CORRIGENDUM - II

Tender No.: UCSL/CC/T/CIVIL/288

CORRIGENDUM-II – TENDER FOR MOVABLE SHED FABRICATION & ERECTION WORK

Qty	Eup No. -		Fin.Wt. -		Material:-	
Scale		Name	Date		Heat treatment:-	
	DRN				Surface coating:- cast / fab.drg.no:-	
	CHK				Unit Name:-	
	APRD				Unit No:-	
Assly/Part Description:- IDLER WHEEL ASSEMBLY					Assly/Part no:- S506-221-000	
					Sheet No:- of sheet

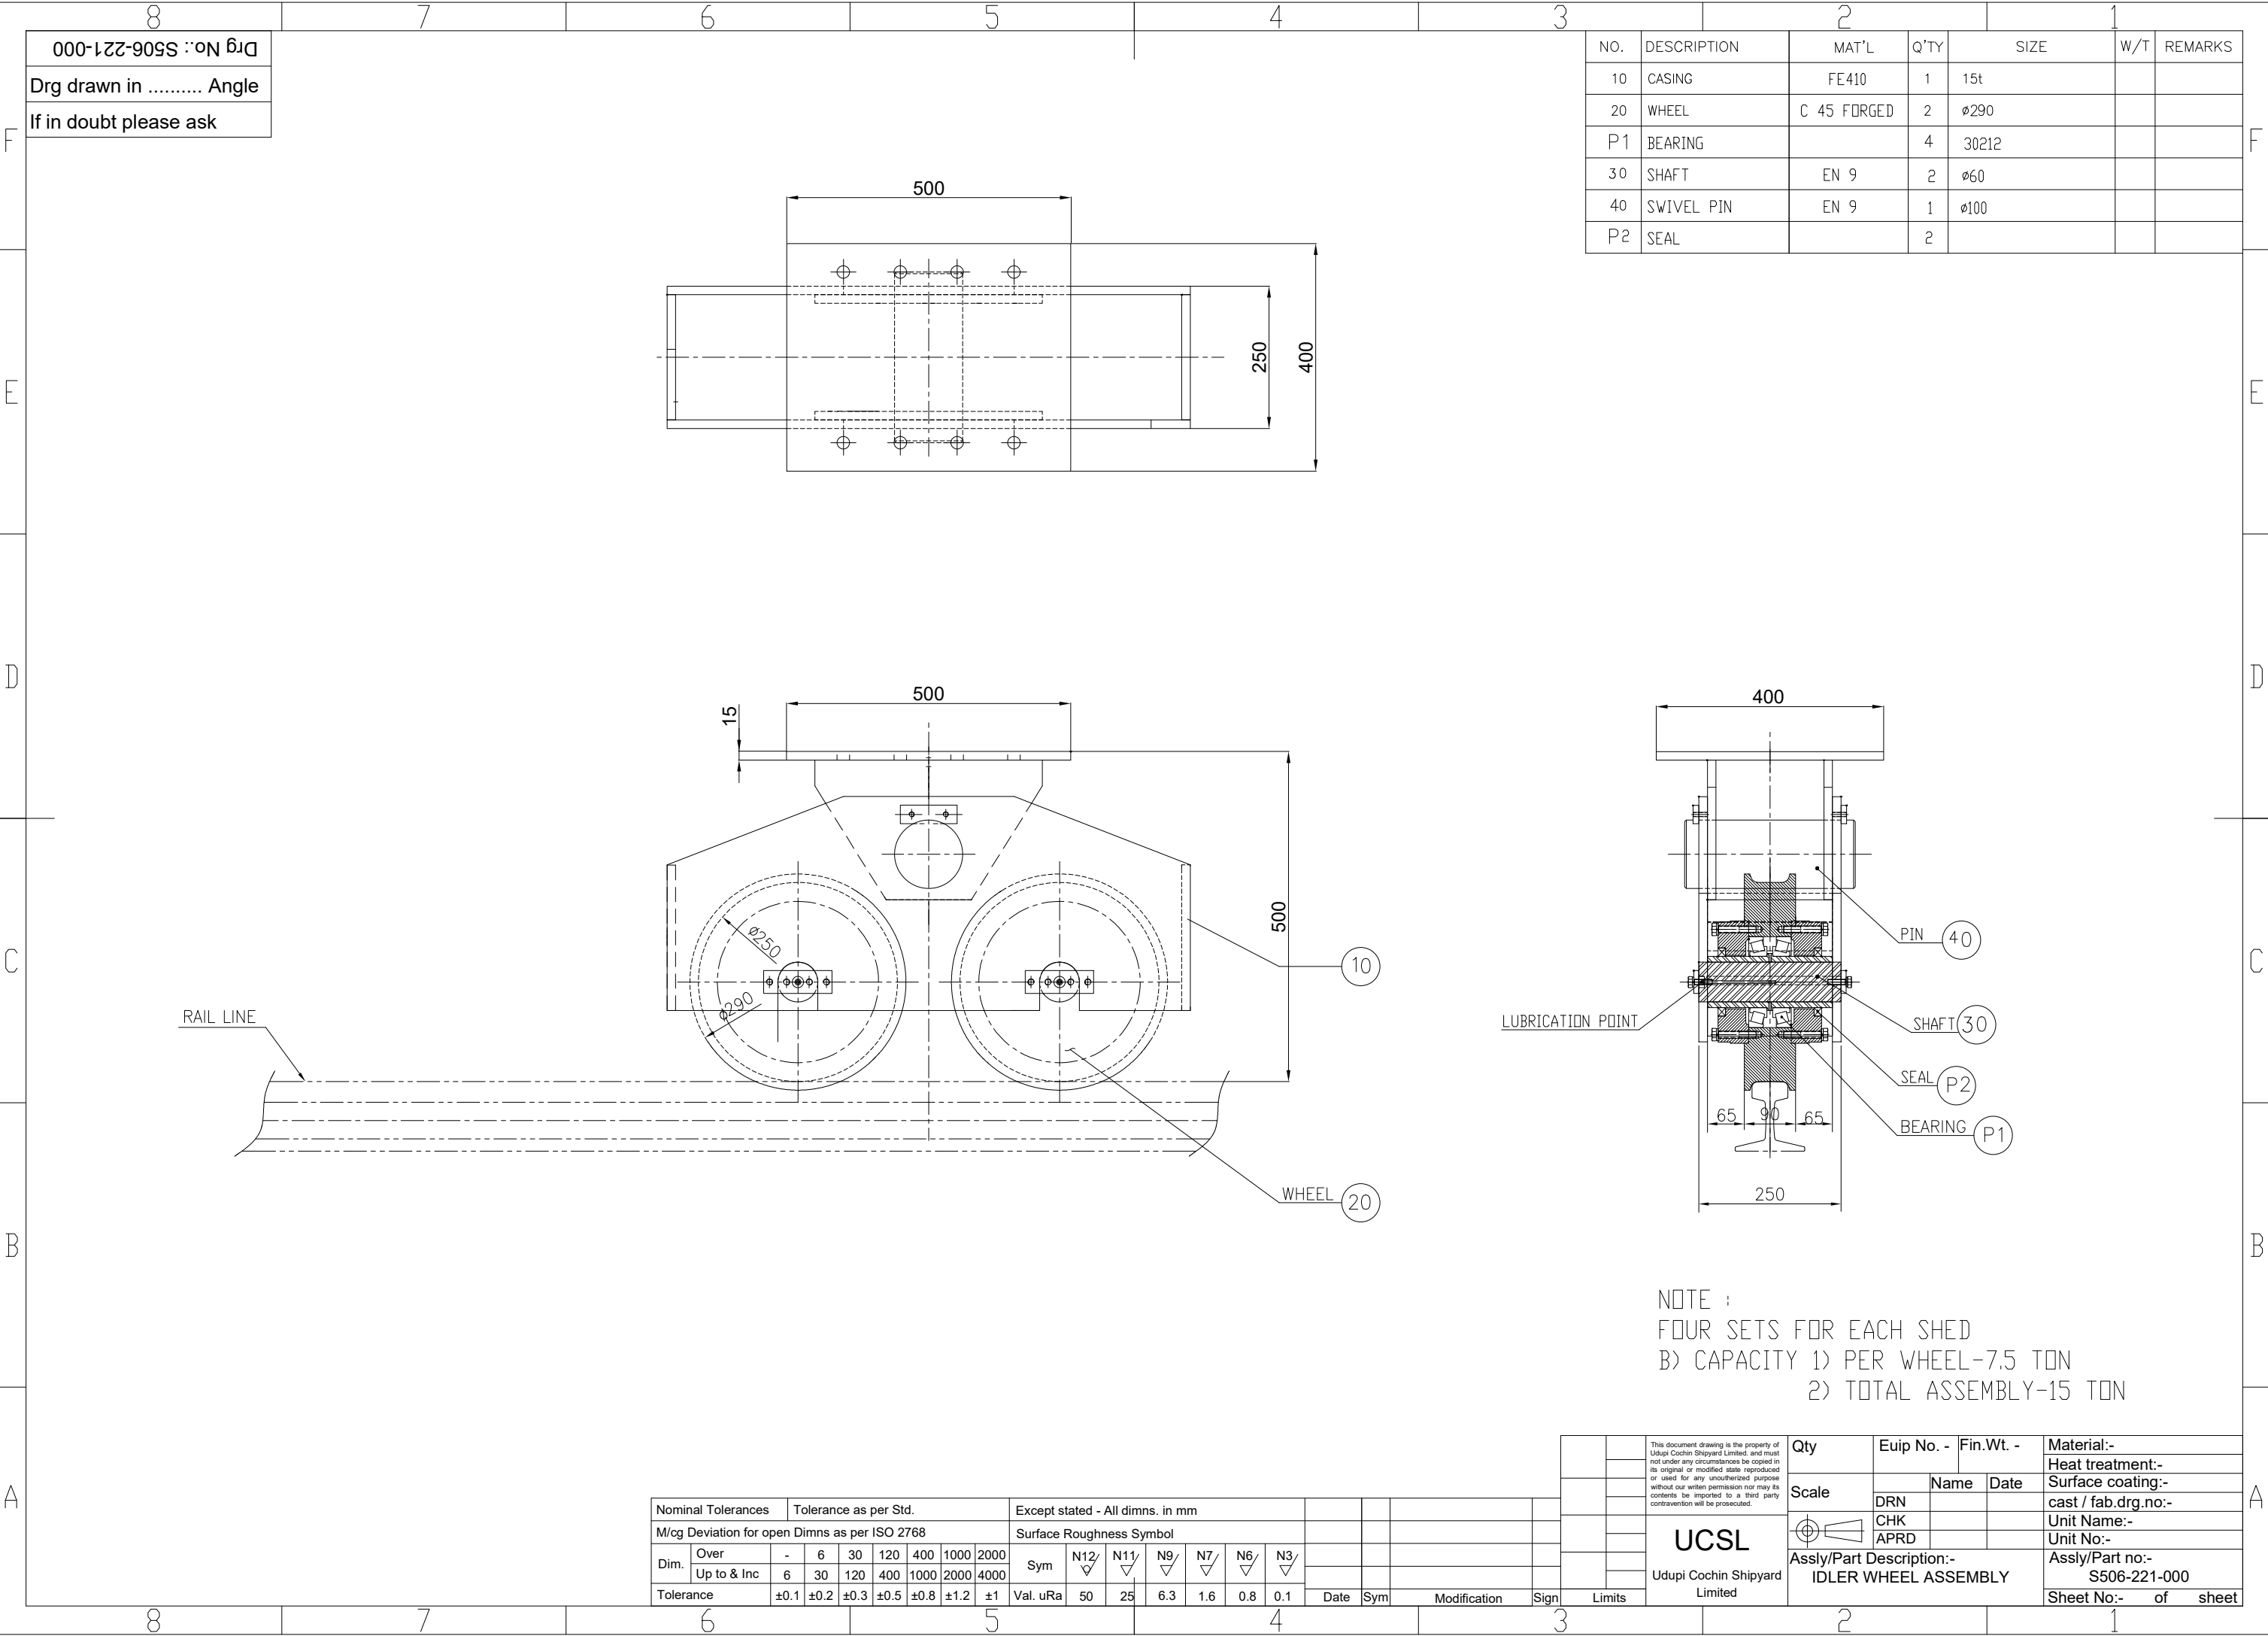
FOR	READ AS
<ul style="list-style-type: none"> Fixing of rails -CR80 to the foundation base plates to be done by the contractor in proper alignment and level. Rail will be supplied by UCSL. As per the drawing Moveable shed wheel will also be supplied by UCSL and the same needs to be fixed by the vendor. 	<ul style="list-style-type: none"> Fixing of rails -CR100 to the foundation base plates to be done by the contractor in proper alignment and level. Rail will be supplied by UCSL. Supply and installation of wheels with brackets, all necessary fixtures, pins, bearings etc. is under contractor scope. Separate scope of work and connection detail drawings for the wheel fixing is given in this corrigendum.

- vi. Fasteners supply is under contractors scope and the same will be paid as per weighment of the fabricated structure.
- vii. Scope of work for Supply and fixing of wheels:

SL No	Description	UOM	Each Shed	Total Qty for 4 Nos of Shed
1	Idler Full Bracket assembly	Set	04	16
2	Wheel Dia of 250 mm Tread and 290mm Flange with Load 7.5-ton capacity, Material specification given in the drawing	Nos	08	32
2b	Wheel assembled with SKF Bearing 30212	Nos	08	32
